BUILDING CONSENT No:- 57316
Issued: 10.8.07

PROPOSED WORK :- Demolish Garage & Shed / Erect New Garage & Carport
SITE ADDRESS :- 6 GAMMACK ST, TEMUKA 8752
VALUE of WORK :- \$9,500.00
ASSESSMENT NO :- 24780/280.00

INSPECTION SHEET (FOUNDATION/SLAB)

INSPECTION SHEET (SUB-FLOOR/PRE-LINE)

Pile/Post/Pad Footings - (Identify element inspected) - Reference NZS 3604-1999

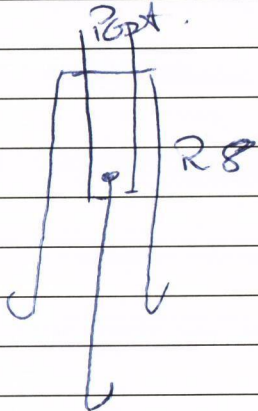
Comments:
R8 rods x 2 passed through posts hung to within 150 of holes; top rod overlaps bottom rod - both rods hooked.
